SAND CREEK RESTORATION

PCD PROJECT NUMBER: CDR-20-004

PUBLIC IMPROVEMENT CONSTRUCTION PLANS

EPC STORMWATER REVIEW COMMENTS
 IN ORANGE BOXES WITH BLACK TEXT

SAND CREEK RESTORATION
POND PLANS
SHEET 37 OF 99
JOB NO. 25188.04

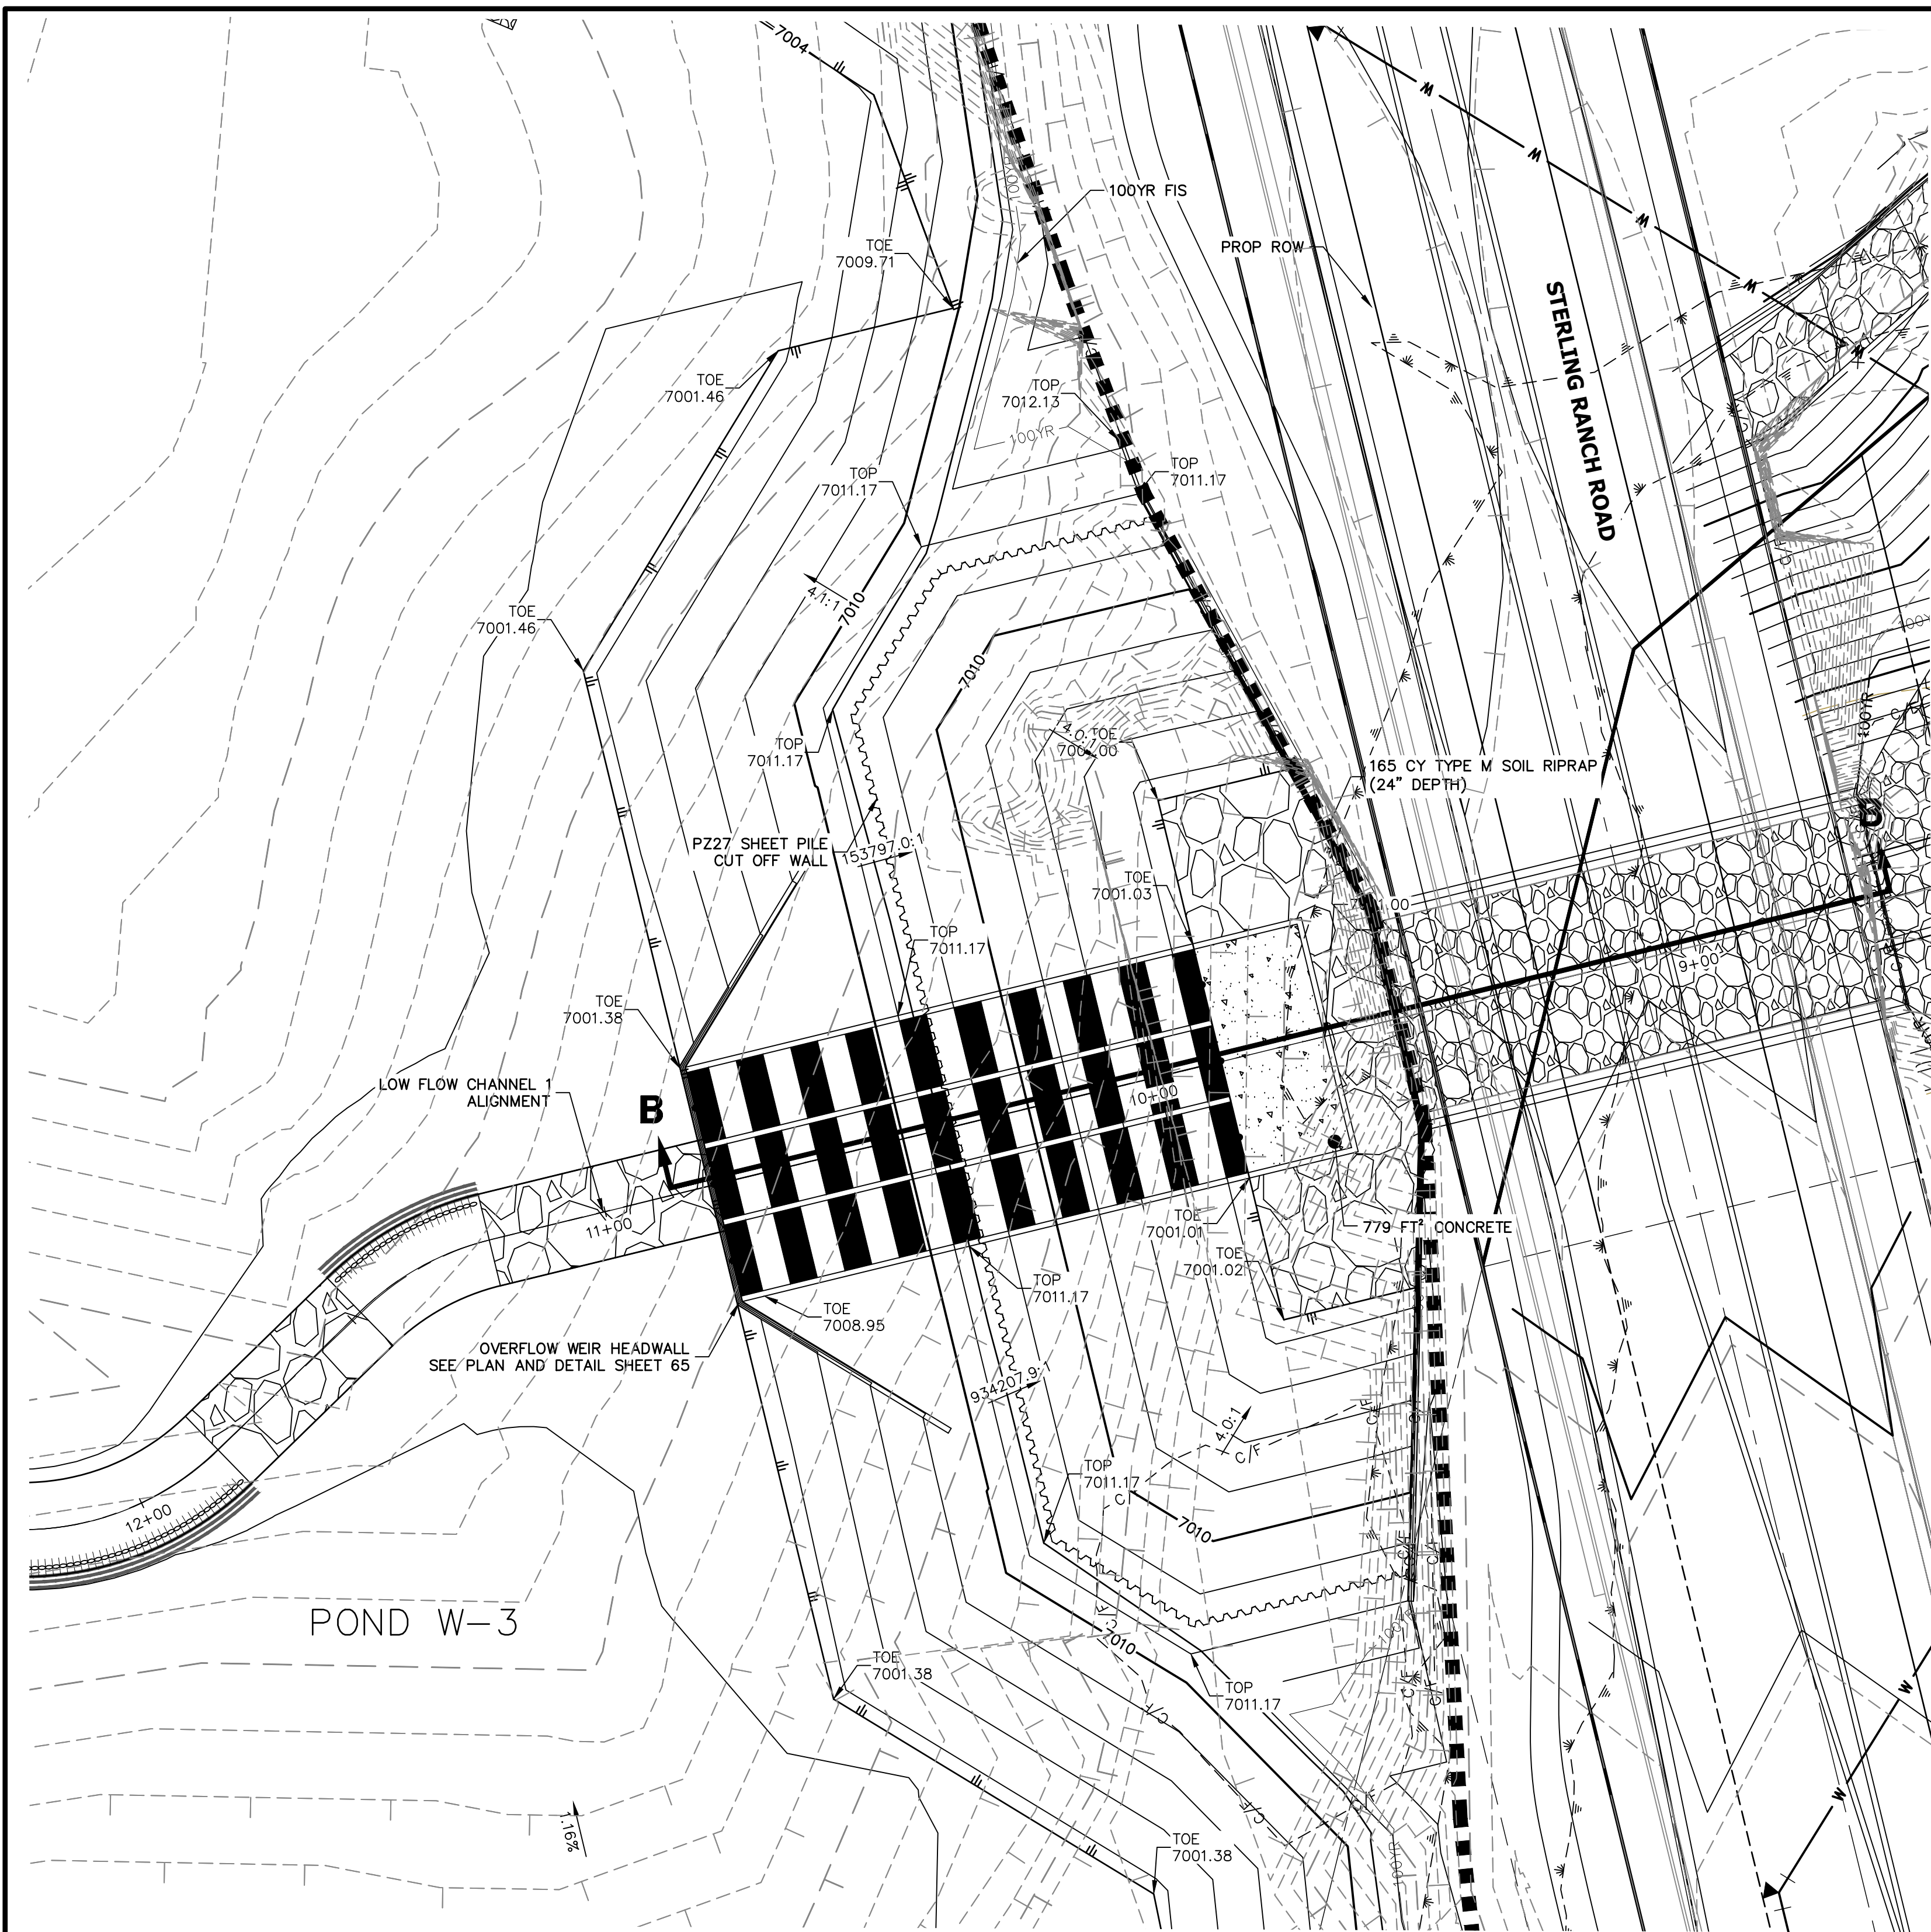
Pond bottom should have a minimum slope of 3% to the low flow channel (USDCM Vol 3, detail T-5). Please adjust to minimize future maintenance needs.

JR-Grading has been revised to remove any slopes steeper than 3:1

JR-Addressed, existing elevation labels have been added

JR-Addressed, detail has been updated

SHEET 42 OF 26
JOB NO. 25188.04

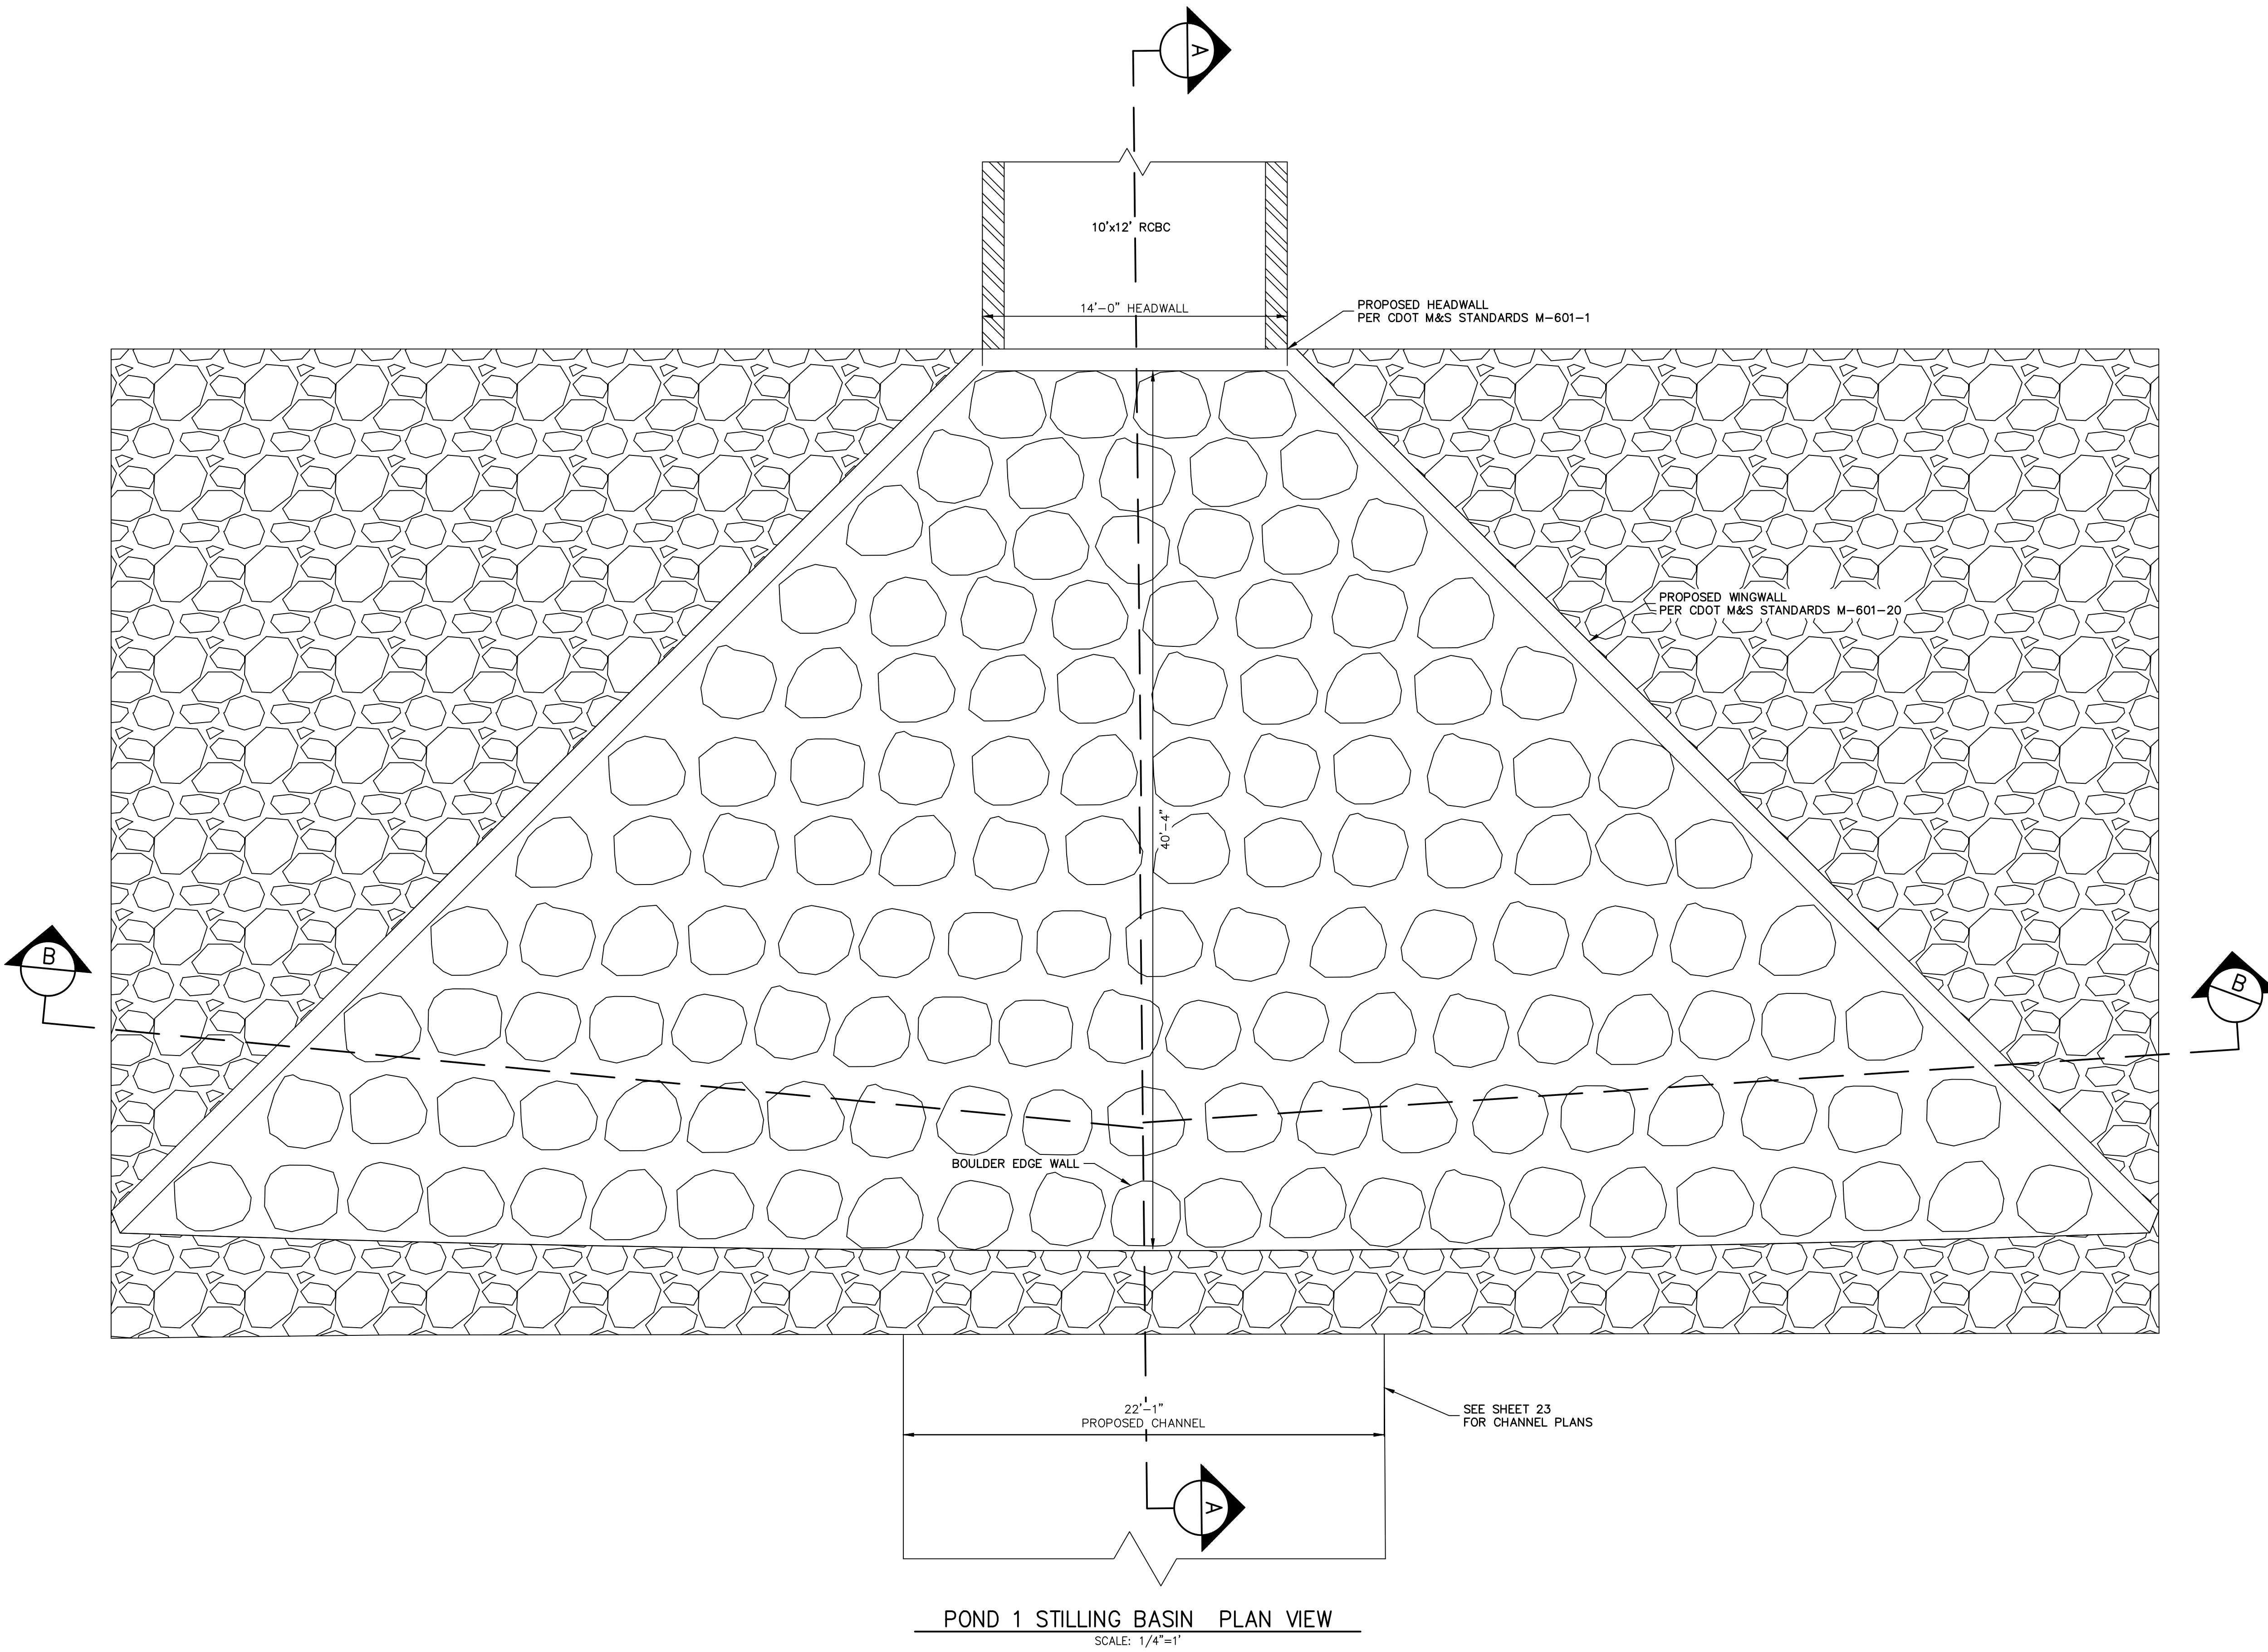
Provide complete structural design for outlet structures

JR-The structural design for the outlet structures will be provided by SAM Engineering, a notes has been added on this sheet to see their plans.

**GRouted STEPPED BOULDER DROP #1 DETAIL
PLAN VIEW**

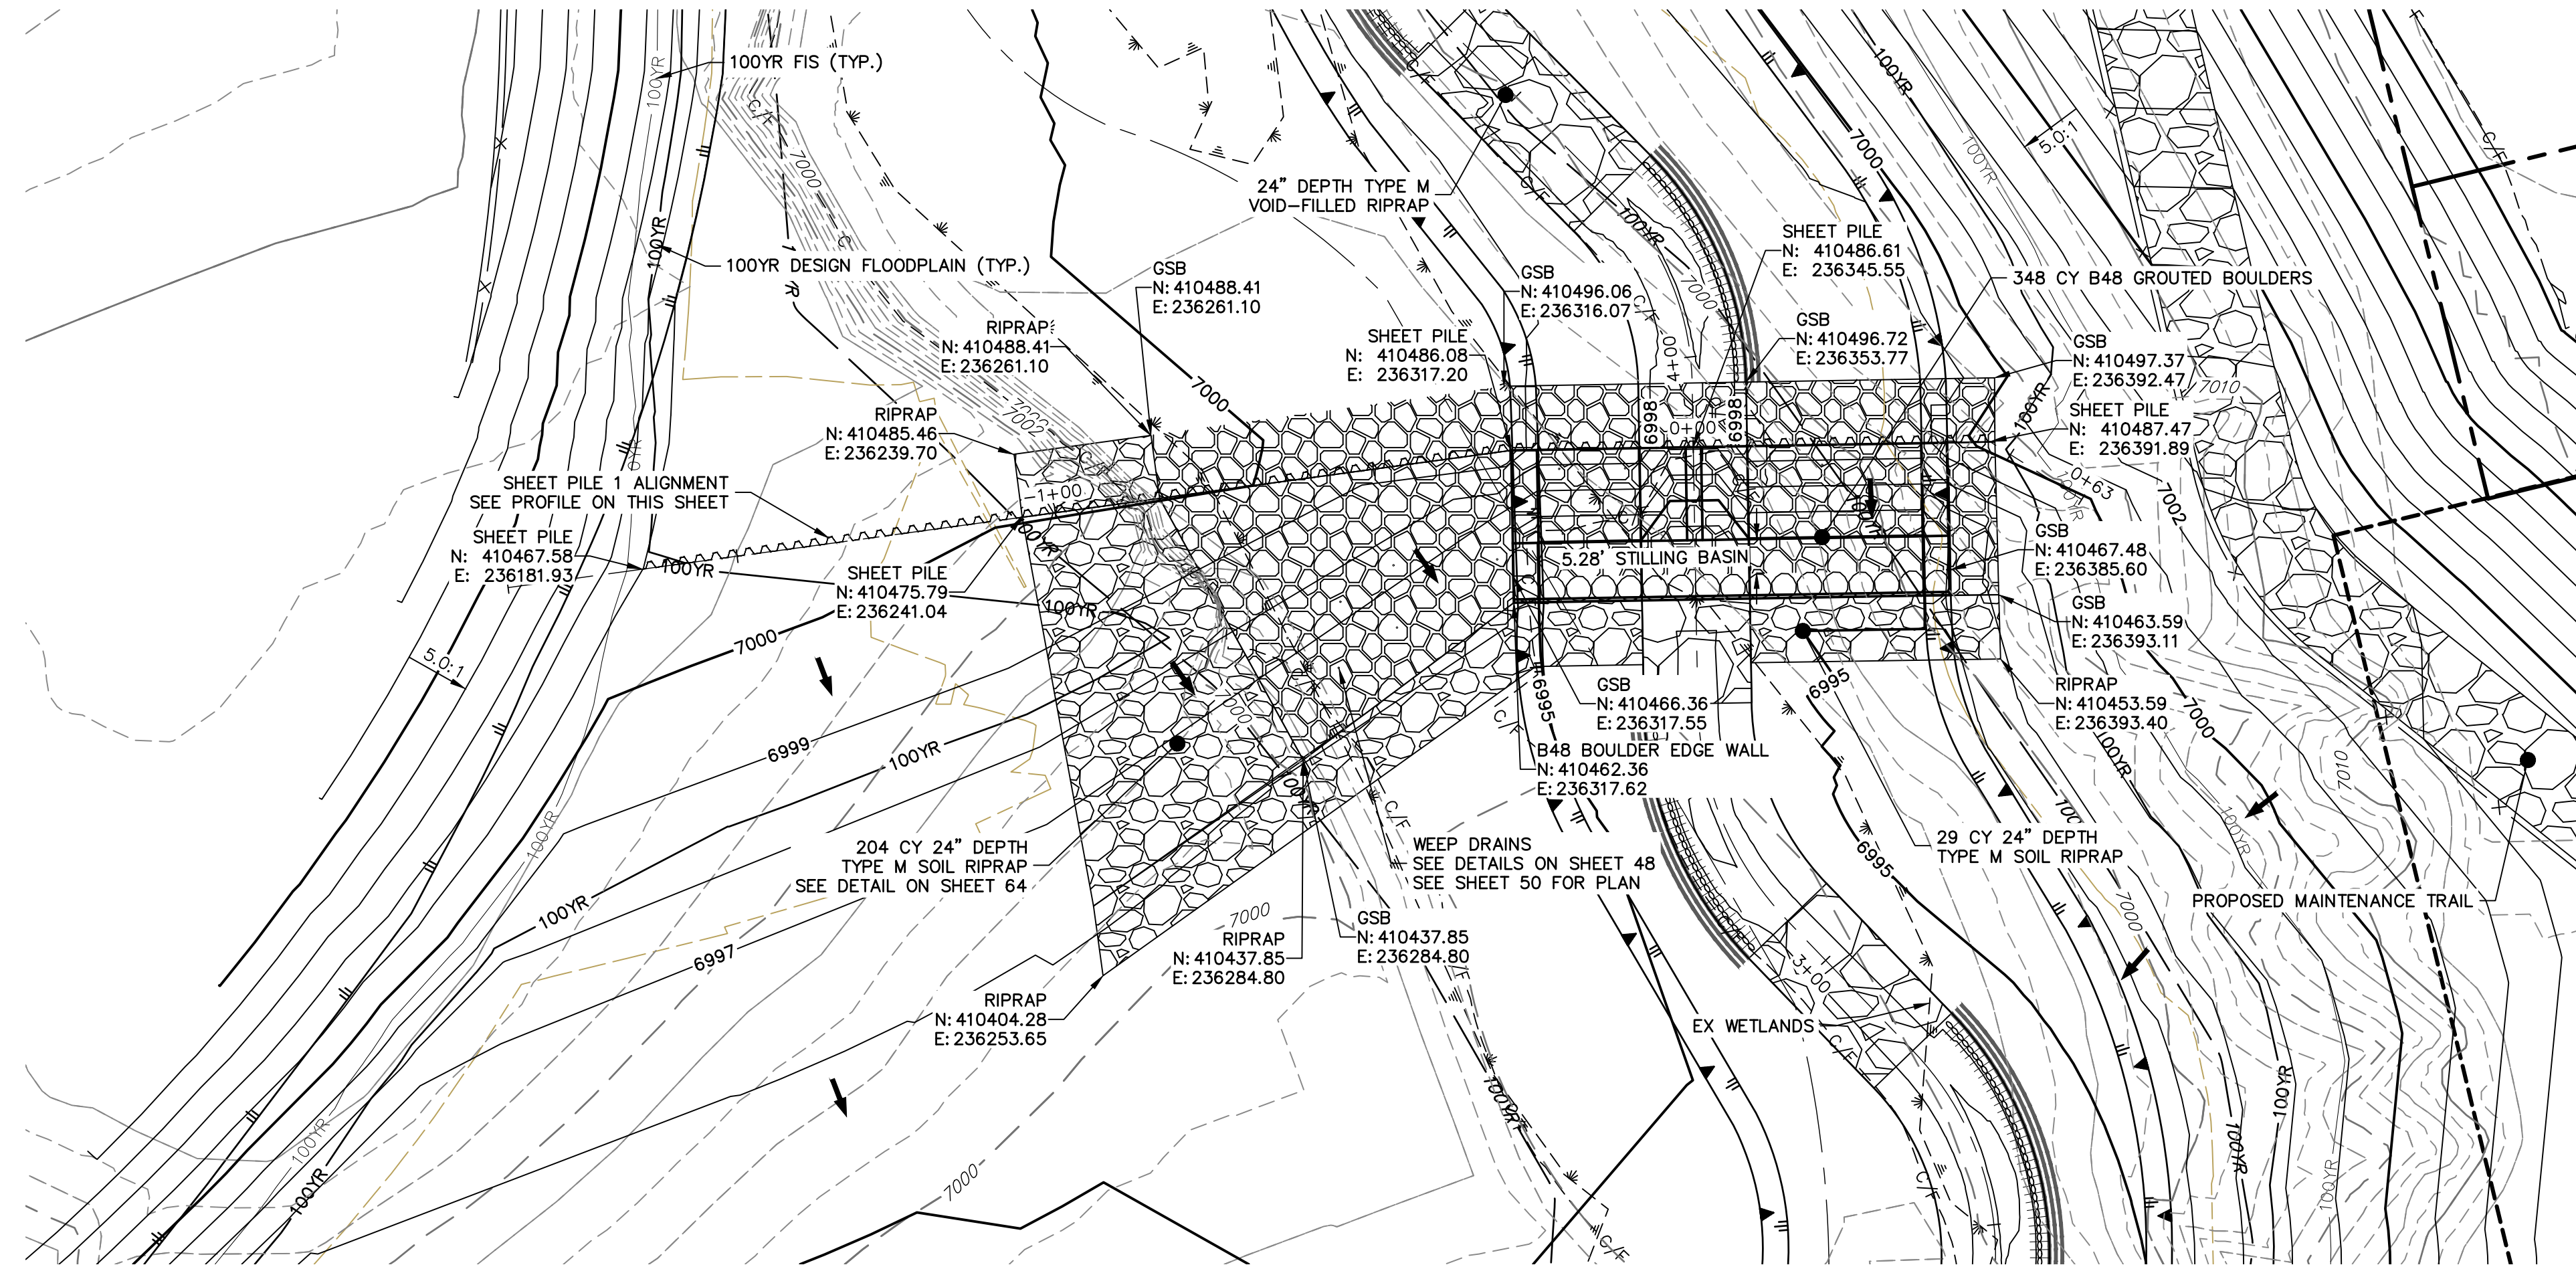
Please show 100-year WS on all 8 cross-sections

JR-Addressed, 100 year WSE has been added to all cross sections
